**Southern Nuclear Operating Company
Vogtle Electric Generating Plant Units 3 and 4
Revision to License Amendment and Exemption Request:
Shield Building Roof Changes (LAR 16-031R1)**

Vogtle Electric Generating Plant (VEGP) Units 3 and 4

Response to NRC Comments (LAR 16-031R1)

(LAR 16-031R1)

Figure 3-4: Proposed UFSAR Figure 3H.5-11 Sheet 6 with Item Labels

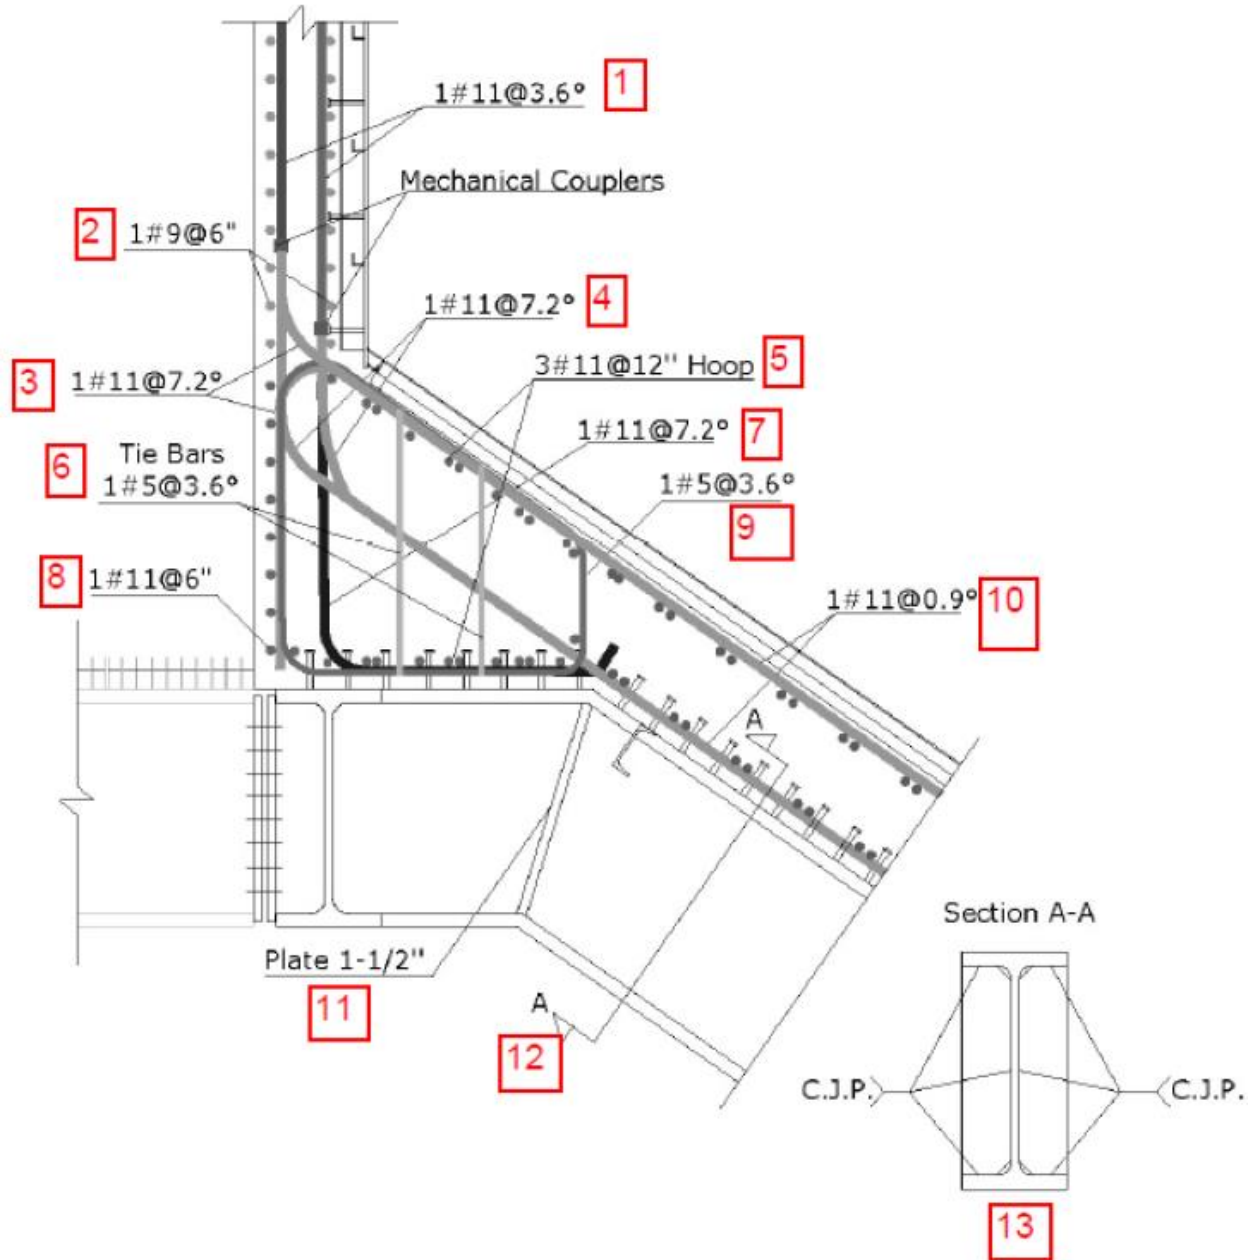
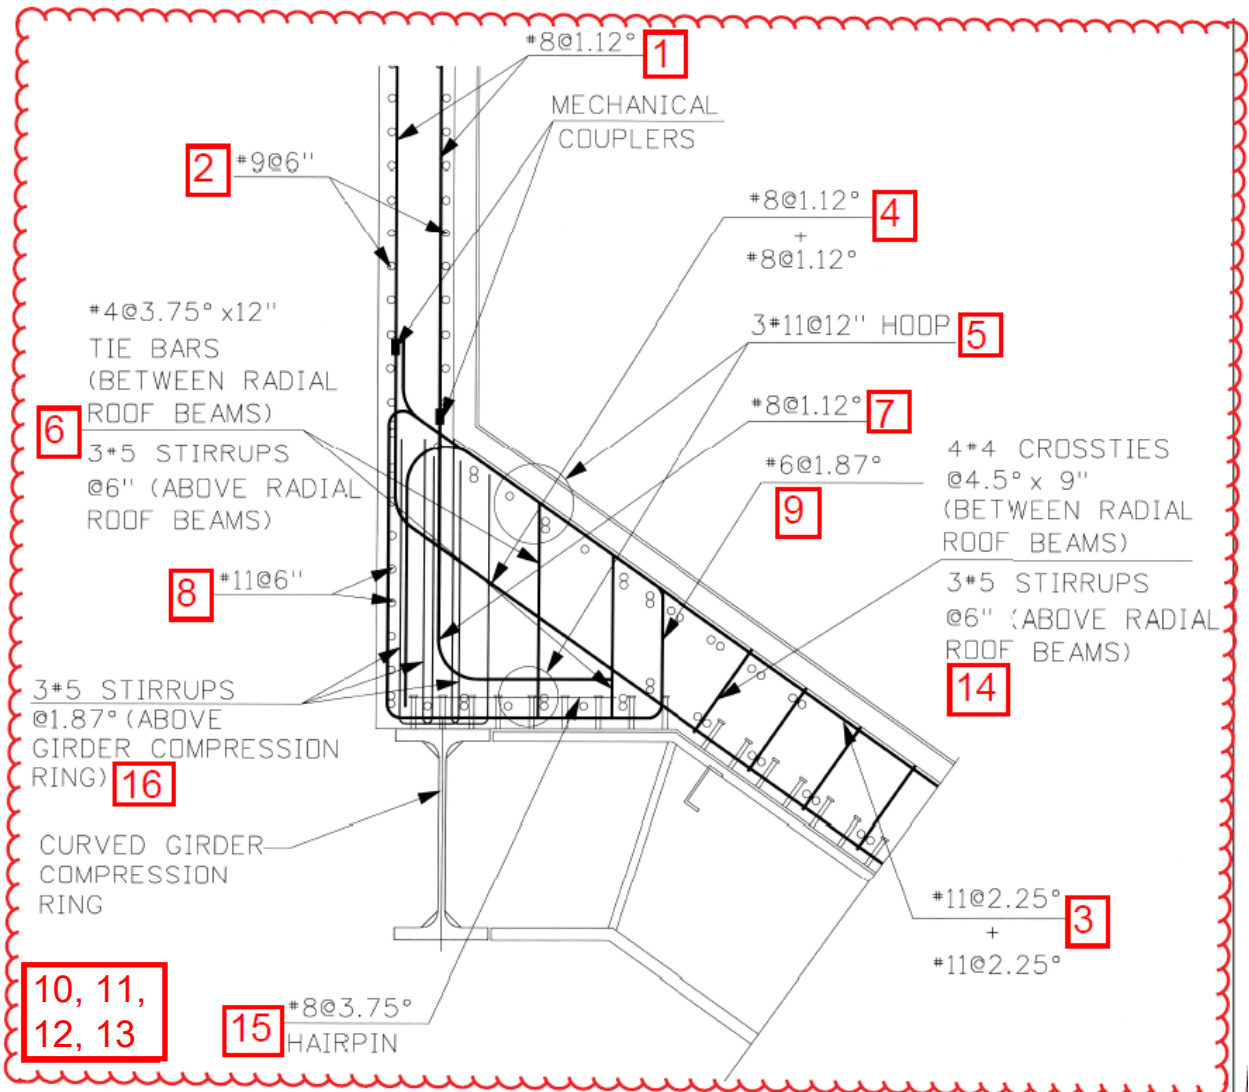
On UFSAR Figure 3H.5-11, Sheet 6 the following changes are made: the vertical reinforcement bars in the tank interior wall are changed from 1 #11 @ 3.6° to #8 @ 1.12°; the top radial reinforcement in the roof slab near the tank interior wall is changed from 1 #11 @ 7.2° to #11 @ 2.25° + #11 @ 2.25°; the bottom radial reinforcement in the roof slab near the tank interior wall is changed from 1 #11 @ 7.2° + 1 #11 @ 7.2° to #8 @ 1.12° + #8 @ 1.12°, and only one set of bottom reinforcement (#8 @ 1.12°) is connected to tank wall vertical reinforcement on the outer face and the other set of bottom reinforcement is developed into the tank wall without connecting the vertical reinforcement at inner face of the tank wall; the layout of 3 #11 @ 12" hoops at the intersection of tank interior wall to roof is changed from 2 #11 (laid out horizontally) + 1 #11 to 2 #11 (laid out vertically) + 1 #11; the tie bars at the intersection of tank interior wall to roof are changed from 1 #5 @ 3.6° to #4 @ 3.75° x 12" tie bars between radial roof beams and 3 #5 stirrups @ 6" above radial roof beams; the dowels of vertical reinforcement at inner face of the tank interior wall are changed from 1 #11 @ 7.2° to #8 @ 1.12°, and the vertical reinforcement bars at inner face of the tank wall are all connected to the dowels instead of partial connecting to dowels and partial connecting to the bottom radial reinforcement in the roof; the closed stirrups at the intersection of tank interior wall to roof are changed from #5 @ 3.6° to #6 @ 1.87° and enclose the hoop reinforcement on the side surface of the intersection area; the reinforcement of 1 #11 @ 0.9° represented for the top and bottom radial reinforcement in roof at half way between the PCS interior and exterior walls is removed as it is not applicable to this figure; the shear ties information in the roof slab is added to the figure to match the design documents, including 4 #4 crossties @ 4.5° x 9" between radial roof beams and 3 #5 stirrups @ 6" above radial roof beams; the hairpin of #8 @ 3.75° is added to match the design documents; 3 #5 stirrups @ 1.87° (above the curved girder compression ring) are added in the intersection area. All changes meet the requirements of ACI 349. In order to better visualize the changes in UFSAR Figure 3H.5-11 Sheet 6 one by one, Table 2 is provided below to summarize the changes with item labels. The design elements in both current and proposed UFSAR Figure 3H.5-11 Sheet 6 are labeled with numbers in Figure 3-3 and Figure 3-4 below.

10	Roof Slab - Top and Bottom Radial Reinforcement	1 #11 @ 0.9°	Removed	It represents roof radial reinforcement at half way between the PCS interior and exterior walls, and is not applicable to this detail.	CA#3
11, 12, 13	Detailed Information	See Figure 3-3	Removed	The information is beyond the level of detail of the UFSAR figure.	CA#4C
14	Roof Slab - Crossties	None	4 #4 CROSSTIES @ 4.5° x 9" (BETWEEN RADIAL ROOF BEAMS), 3 #5 STIRRUPS @ 6" (ABOVE RADIAL ROOF BEAMS)	The crossties in the roof slab are part of the design and always existed in the design documents. The UFSAR figure is updated to match the design documents.	CA#3
15	Intersection – Hairpin	None	#8 @ 3.75° HAIRPIN	The hairpin is added to the UFSAR figure to match the design documents.	CA#3
16	Intersection – Stirrups	None	3 #5 STIRRUPS @ 1.87° (ABOVE CURVED GIRDER COMPRESSION RING)	The stirrups in the intersection above the curved girder compression ring are added to the UFSAR figure to match the design documents.	CA#3

- Revise reinforcement design details on Sheet 5. (CA#3, CA#4C)
- Revise reinforcement design details on Sheet 6. (CA#3, CA#4C)
- Dimensions are rounded to two decimal places. (CA#4E)

UFSAR Figure 3H.5-11 (Sheet 6 of 6) Design of Shield Building: Tank/Compression Ring Roof Interface Reinforcement - Revise information as shown below.

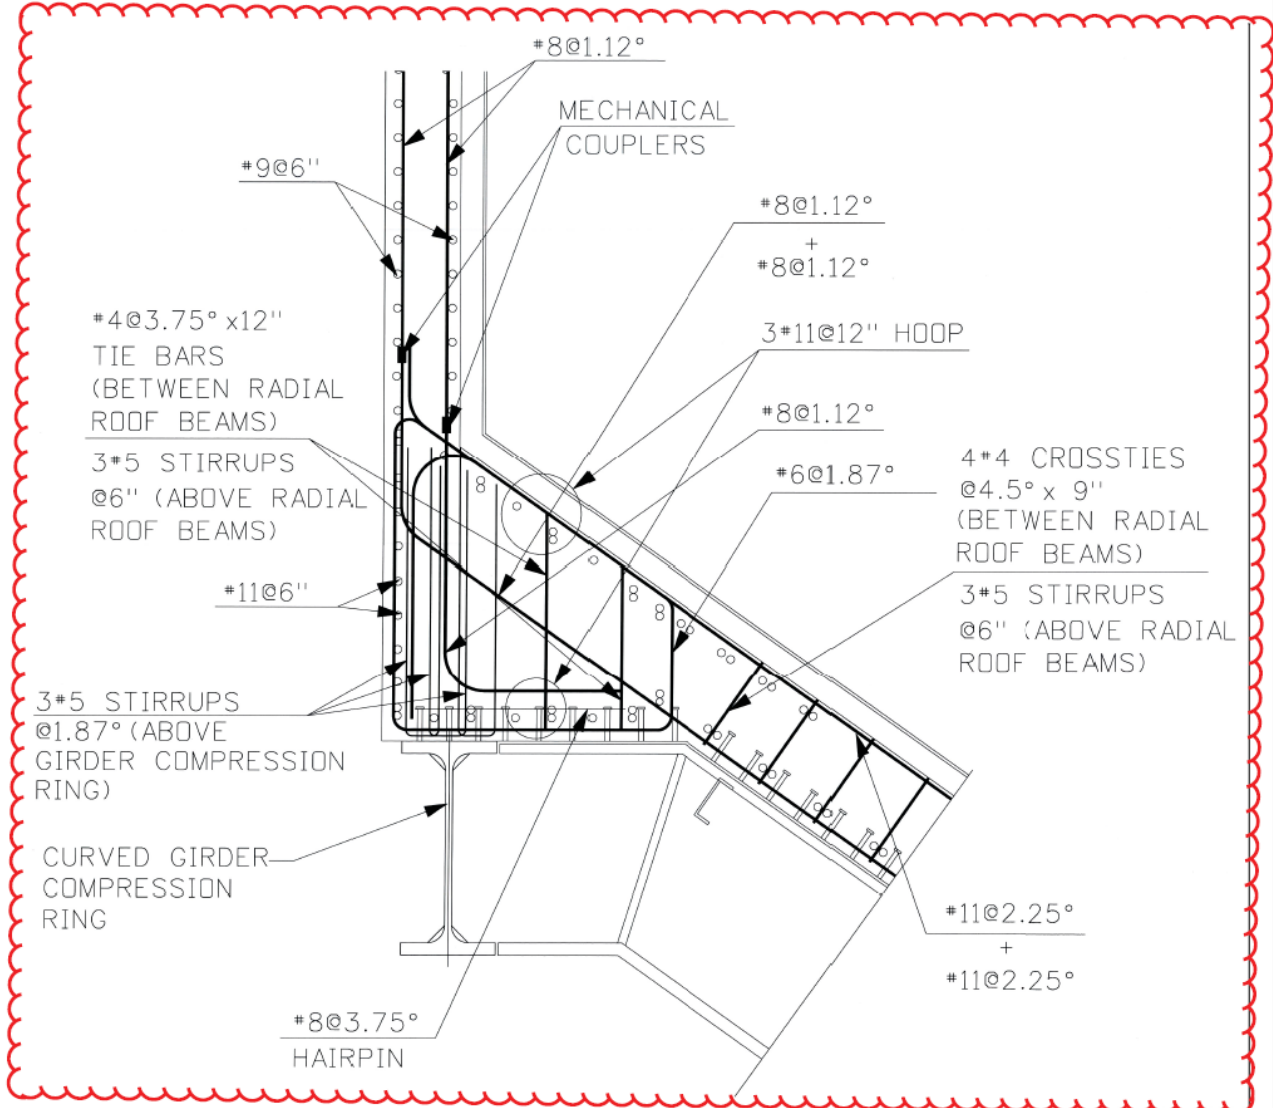
- Identify “Curved Girder Compression Ring” on Sheet 6. (CA#4G)
- Remove construction detail on Sheet 3. (CA#4C)
- Identify structural elements on Sheet 3, and add clarification information to the annotation on Sheet 3. (CA#4H)

UFSAR Figure 3H.5-14 Elevation View of Tension Ring and Air Inlets - Revise information as shown below.

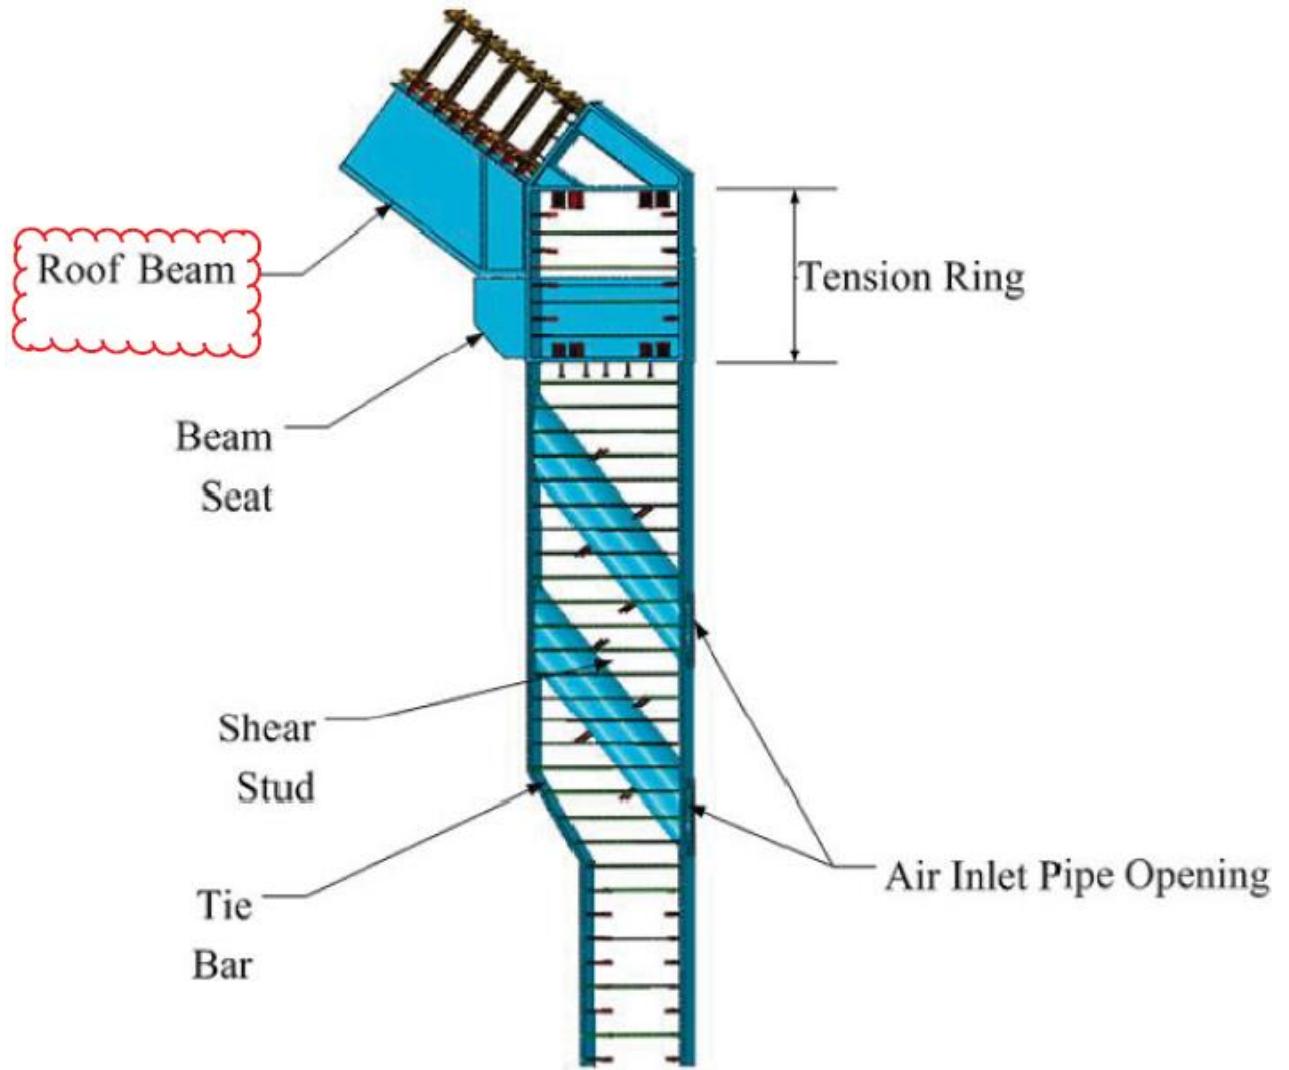
- Remove reference to beam size. (CA#1)
- Change roof beam designation. (CA#4F)

UFSAR Figure 3H.5-15 Shield Building Tension Ring - Revise information as shown below.

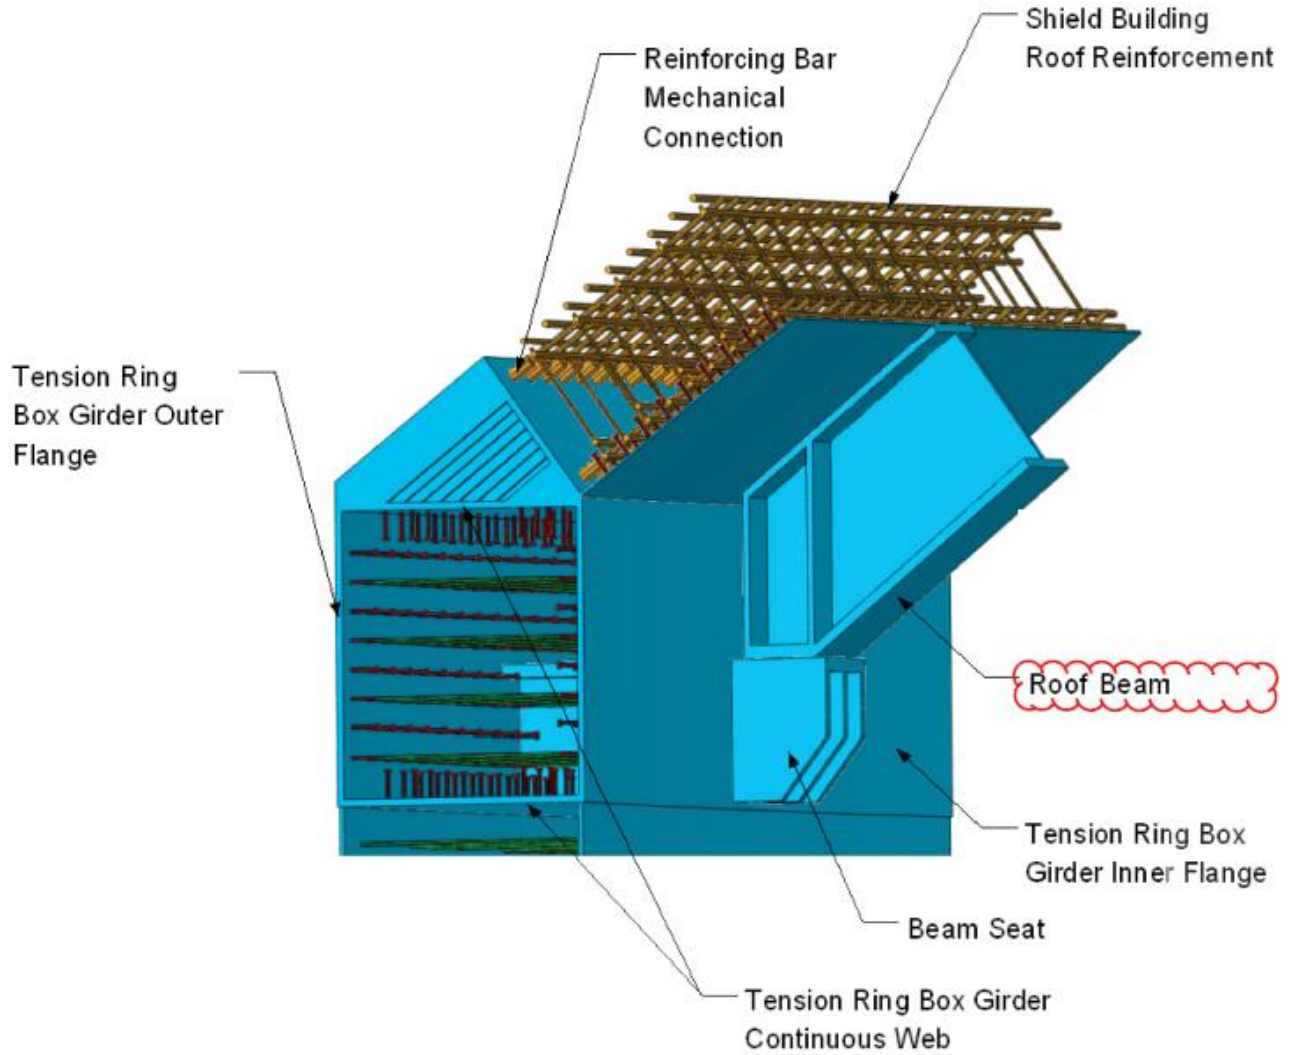
- Remove reference to beam size. (CA#1)
- Change roof beam designation. (CA#4F)
